S-TYPE

S303-24

TECHNICAL BULLETIN

V6 Engine MIL Lamp On/DTC P0332 –
Water Entry In Knock Sensor Connector –
Install Sealing Patch

ILLUSTRATION 1

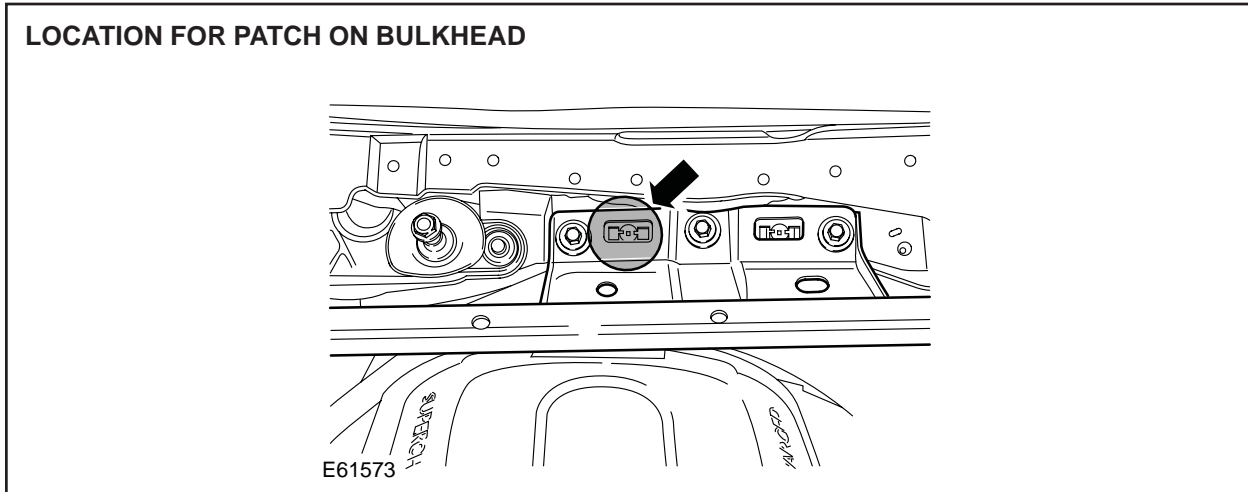
5. Switch 'OFF' PTU, disconnect from vehicle and return WDS to original location.
6. Remove the cowl panel grille (see Global Technical Reference GTR Workshop Manual, section 501-02).
7. Clean the area on the bulkhead bracket of the suspension turret brace where the adhesive patch will be applied (Illustration 1).

8. Ensure the plastic insert is centered in the rectangular hole of the brace.
9. Remove and discard the backing from the adhesive patch and install the patch centered over right-hand rectangular hole furthest to the rear the brace (see illustration 1).
10. Install the cowl panel grille (see Global Technical Reference GTR Workshop Manual, section 501-02).
11. Remove the **left-hand** (upper) knock sensor (see Global Technical Reference GTR Workshop Manual, section 303-14A, SRO 18.30.92).
12. Remove the engine harness electrical connector for the knock sensor from the mounting, and position it downwards to ensure no water is present in the PVC tube that covers the harness.

ILLUSTRATION 3

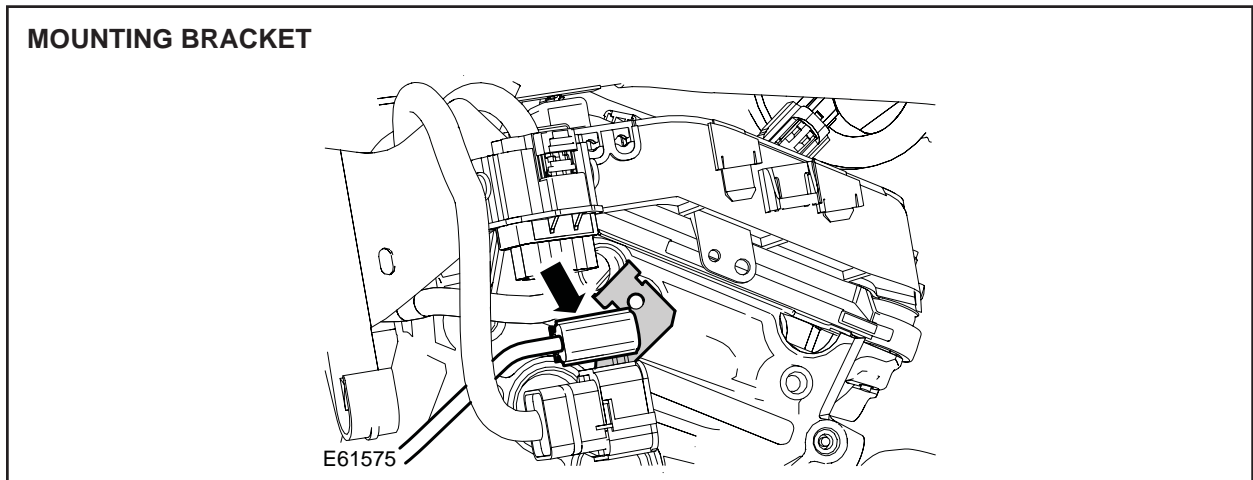
13. Install the engine harness electrical connector for the knock sensor in the new mounting position (Illustration 3).
